## **Stage 1 Road Safety Audit**

**Proposed Wind Farm at Inchamore Td, Coolea, Co Cork**

On behalf of Coillte CGA \ SSE Renewables Ltd

**April 2023**

#### 3.3.2 Development Junction - Surfacing

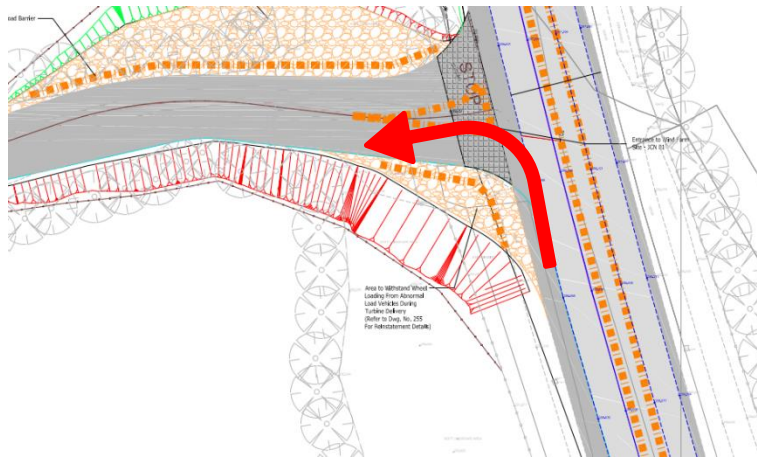
**Problem:** The development junction is made from unbound granular material. There is risk that stones may be dragged into the National Road.

**Hazard:** Loose material in the road may be thrown up into the windscreen of other vehicles, or strike cyclists.

**Recommendation:** Provide a bound surface to the access road.

### 3.3.4 Turning Area

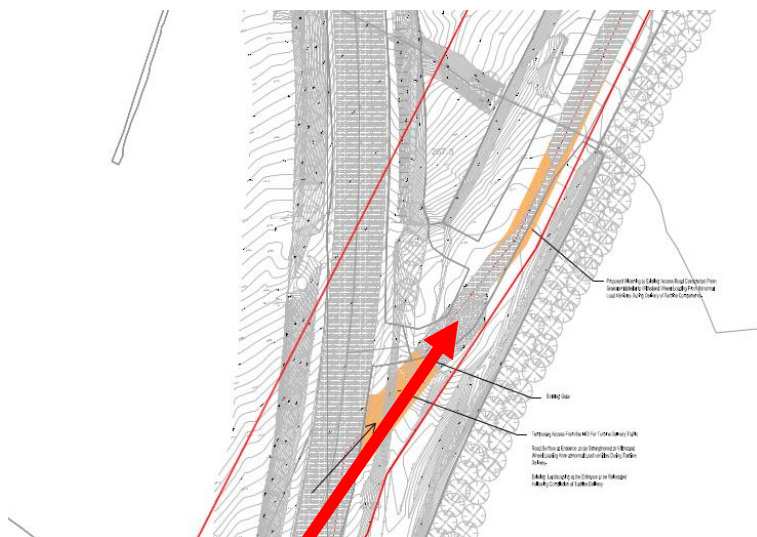
**Problem:** The audit team have been advised that vehicles departing the development will turn left from the development junction and undertake a turn at a location further to the north. The formation of the inbound junction for turning may appear as a continuation of the National Road during hours of darkness.

**Hazard:** Northbound National Road drivers may errantly divert from the mainline to enter this new junction. Impact with southbound National Road traffic may result.

**Recommendation:** Ensure this junction does not appear as a continuation of the National Road under any lighting conditions.

**Title**  
WINDFARM LAYOUT  
SITE ENTRANCE - OPTION 3  
SITE LAYOUT - LEFT IN / LEFT OUT  
SHEET 1 of 2

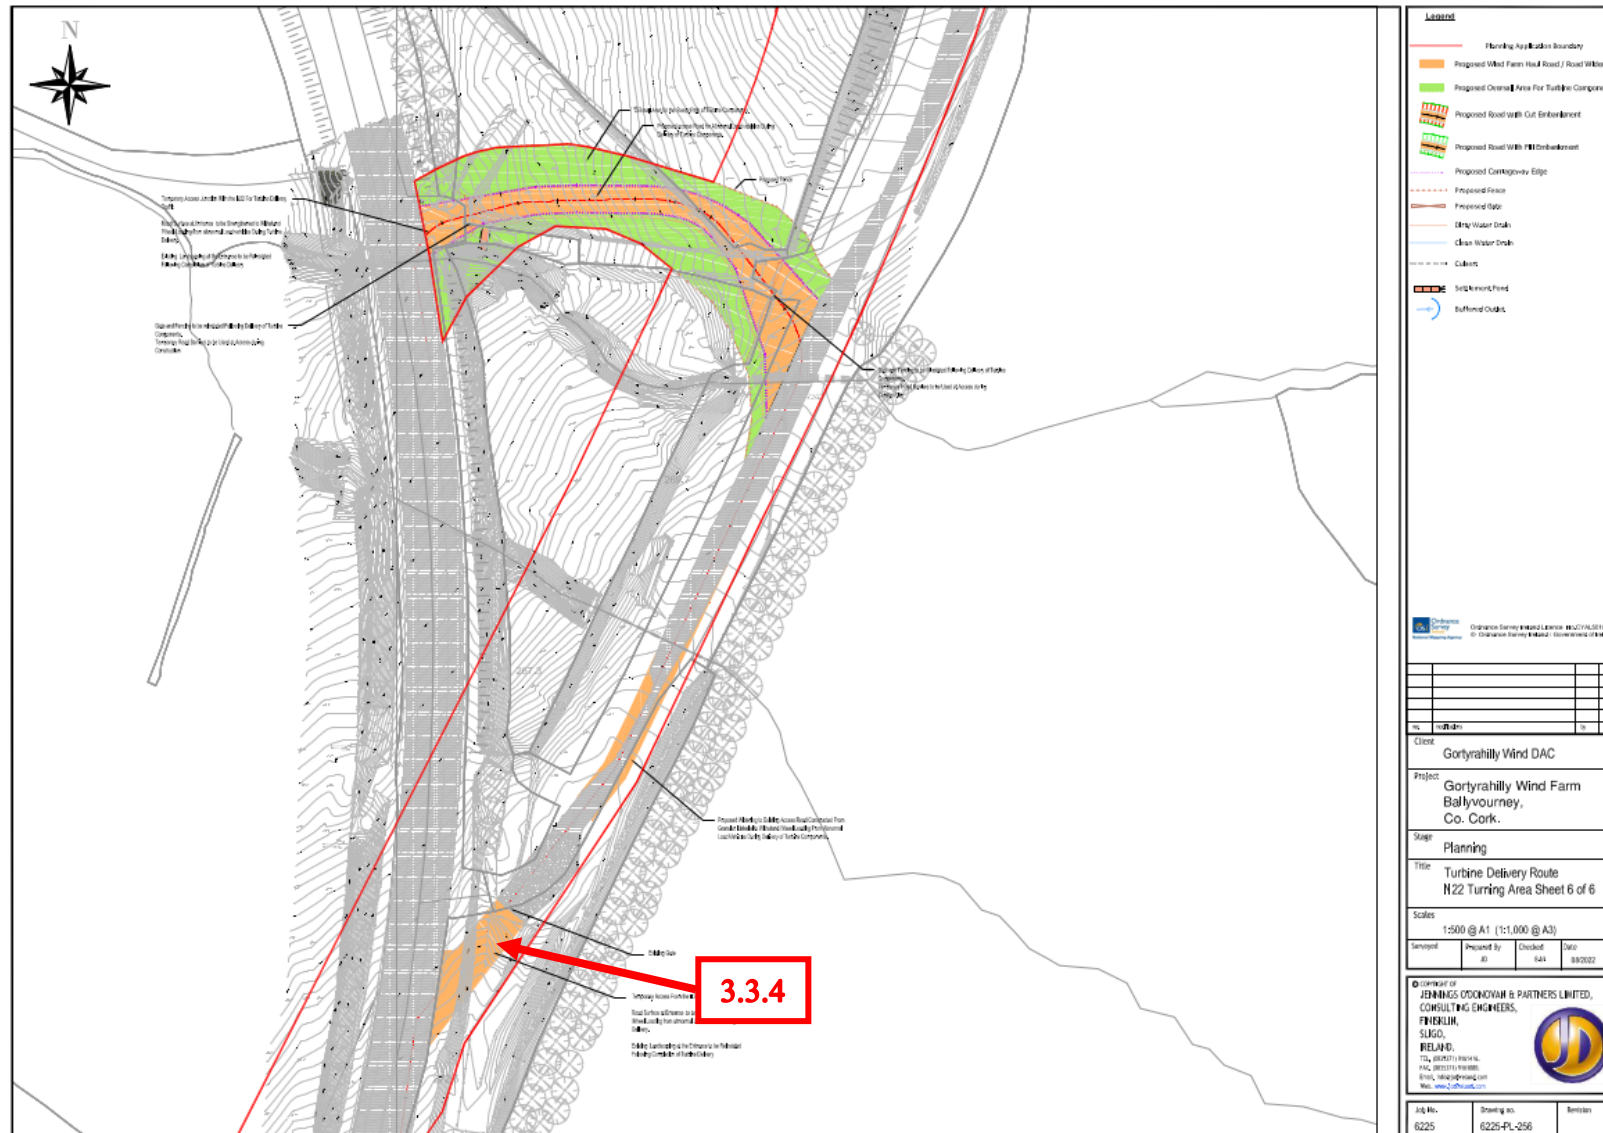
**Problem:** The proposals indicate barriers to be provided to close down the national road southbound offside lane, where the climbing lane exists. This area of the national road is up a steep gradient.

**Hazard:** Faster moving traffic may attempt to overtake slower moving vehicles that are particularly slow due to the road gradient, and cut back in just prior to the temporary barriers. Collisions with the barriers or side swipe collisions with the slow moving vehicle may result.

- Retain the dual lane set up for the full extent of the climbing lane.
- Adjust the refuge island within the mouth of the development junction such that right turning into the junction is near impossible for long vehicles.
- Ensure all drivers destined for the development are instructed to approach from the south only.
